## Riley Purgatory Bluff Creek Watershed District Permit Application Review

**Permit No:** 2023-020

**Project:** The project proposes the development of a new veterinary clinic and associated onsite parking areas and driveway in Eden Prairie, MN. The project includes a subsurface stormwater facility to provide volume control, water quality, and rate control.

**EROSION CONTROL  
PLAN**

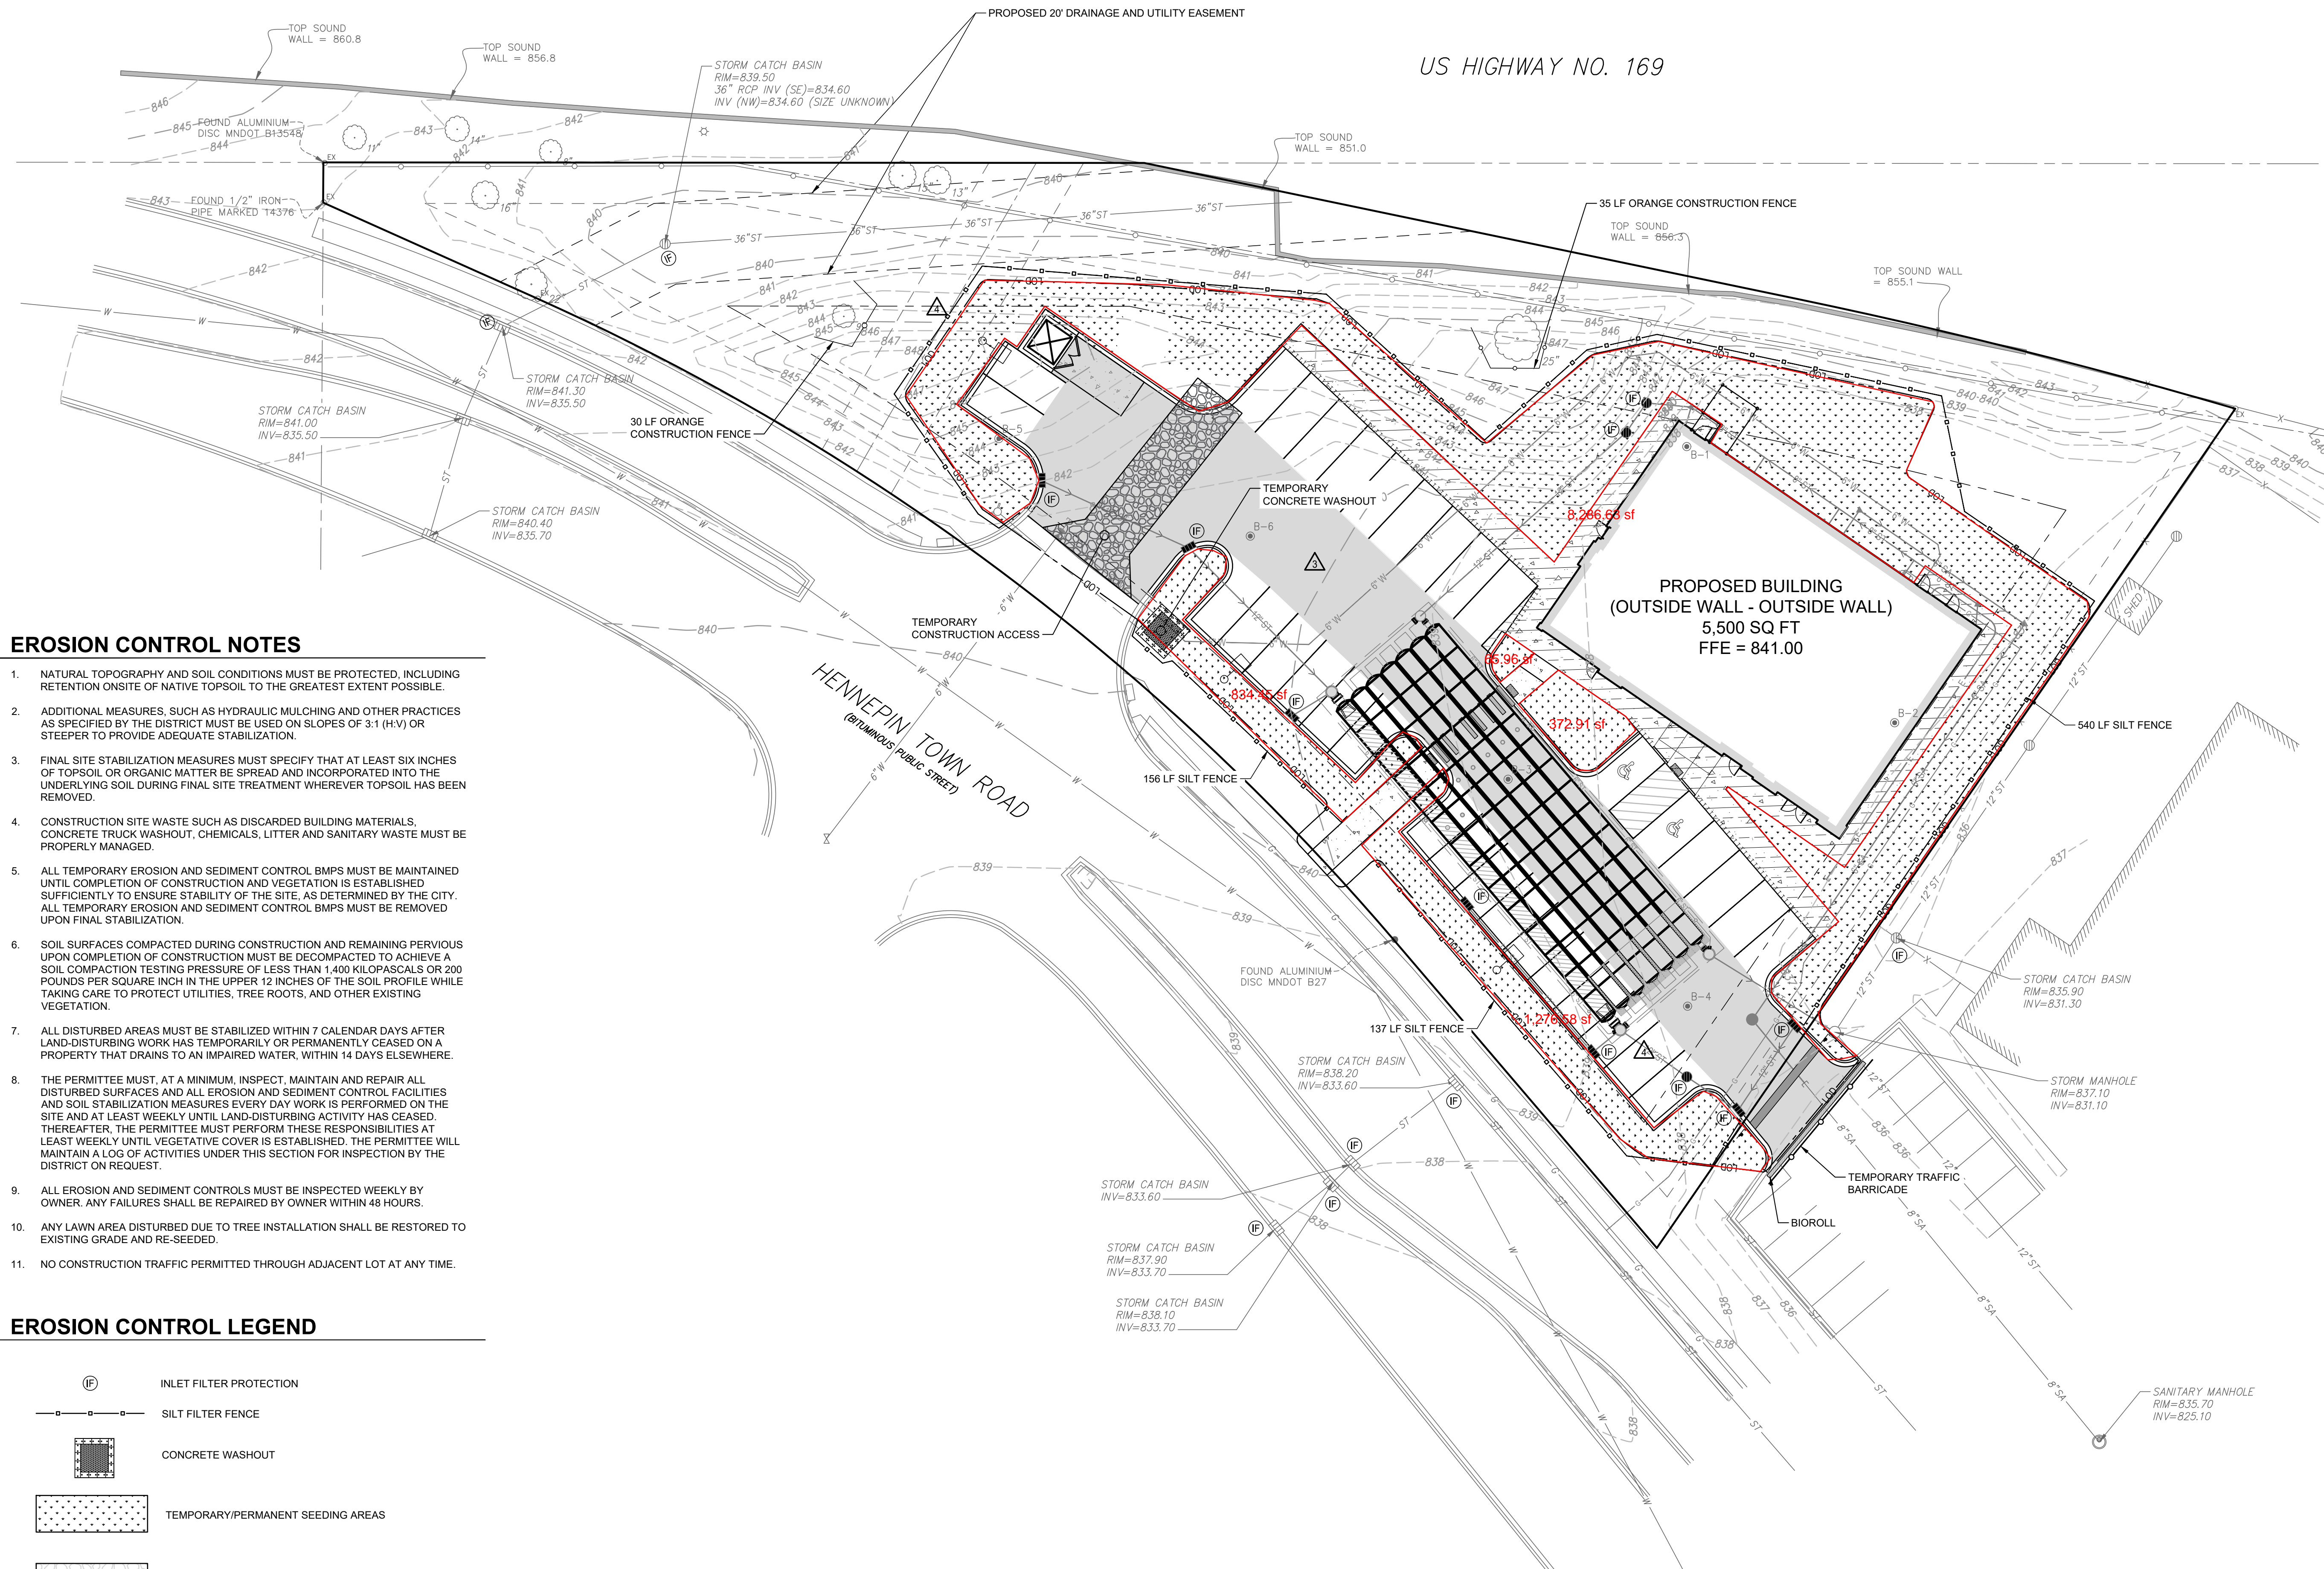
The erosion control plan prepared by Farnsworth Group includes installation of perimeter control (silt fence and erosion logs), a stabilized construction entrance, inlet protection, daily inspection, temporary concrete washout area, placement of a minimum of 6 inches of topsoil (at 5% organic matter), decompaction of areas compacted during construction. To conform to RPBCWD Rule C requirements, the following revisions are needed:

- C1. The Applicant must provide the name, address and phone number of the individual who will remain liable to the District for performance under this rule and maintenance of erosion and sediment-control measures from the time the permitted activities commence until vegetative cover is established.
